## **Responses to NRC Request for Additional Information**

### **Materials License No. STB-401**

### **Mallinckrodt Inc, Docket No. 40-6563**

By application, dated May 14, 2003, Mallinckrodt, Inc., (Mallinckrodt) submitted an amendment request to the U.S. Nuclear Regulatory Commission (NRC) to amend Materials License No. STB-401 to authorize the Phase II Columbium - Tantalum (C -T) decommissioning for the purpose of license termination. On December 16, 2004, NRC staff members met with representatives of Mallinckrodt to discuss NRC's draft health physics and dose modeling comments on the Phase II C-T Decommissioning Plan (DP). Mallinckrodt has addressed the request for additional information related to that meeting in a response previously sent to the NRC dated August 1, 2005. This response addresses additional information requested by NRC staff to determine whether Mallinckrodt has demonstrated compliance with regulatory requirements. The additional requested information is organized by the following areas: License Termination, Planned Decommissioning Activities and Remediation, Environmental Monitoring and Controls, Radiation Safety for Workers, Final Status Survey, Waste Manag

Figure 9-1. C-T Phase II Decommissioning Organization

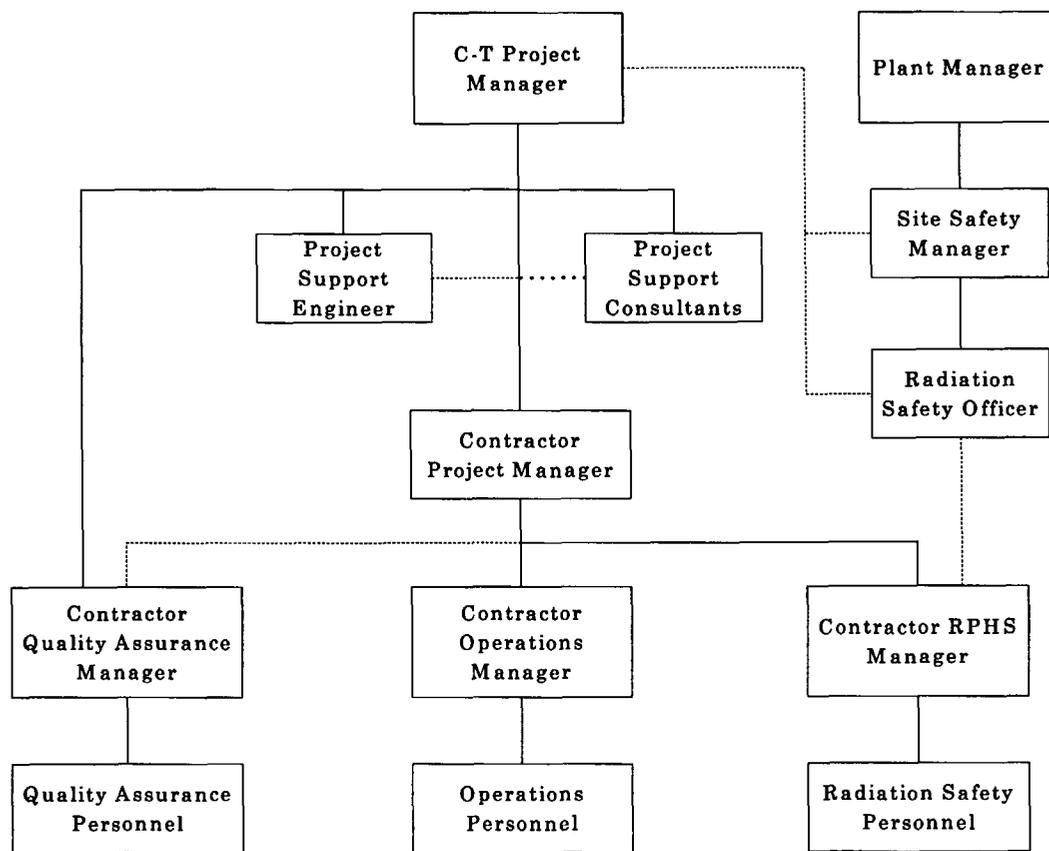
93. 1. Provide clarification of Mallinckrodt's decommissioning organization. Descriptions on page 9-2 and Figure 9-1 are not consistent. Furthermore, there is no "SSRO" on the organization chart in the description. [see page 9-4 of the DP.]

98. 6. Provide a description of the management interfaces that will be in place between Mallinckrodt's management and onsite supervisors, and contractor management and onsite supervisors.

An SSRO, mentioned in DP §9.2.2 on page 9-4, is intended to refer to Mallinckrodt's Radiation Safety Officer, or RSO. DP §9.2.2 is being revised to refer to Mallinckrodt's RSO as one who also reviews and approves procedures addressing radiation safety issues.

CT 2 DP, §9.1.3 and §9.3.2 are being revised to provide information requested in this item and to align with the revised organization chart, Figure 9-1.

Formal organizational relationships among Mallinckrodt and contractor managers and supervisors are identified in CP §9.1 and Figure 9-1. That decommissioning occurs on the same plant site where Mallinckrodt managers and supervisors are sited is an advantage for interface with contractor supervision. There will be routine meetings between the Mallinckrodt CT project manager and other Mallinckrodt managers, as appropriate, with contractor supervision. These meetings would typically be held on a weekly basis. There will be routine monthly reports on project status and activities.
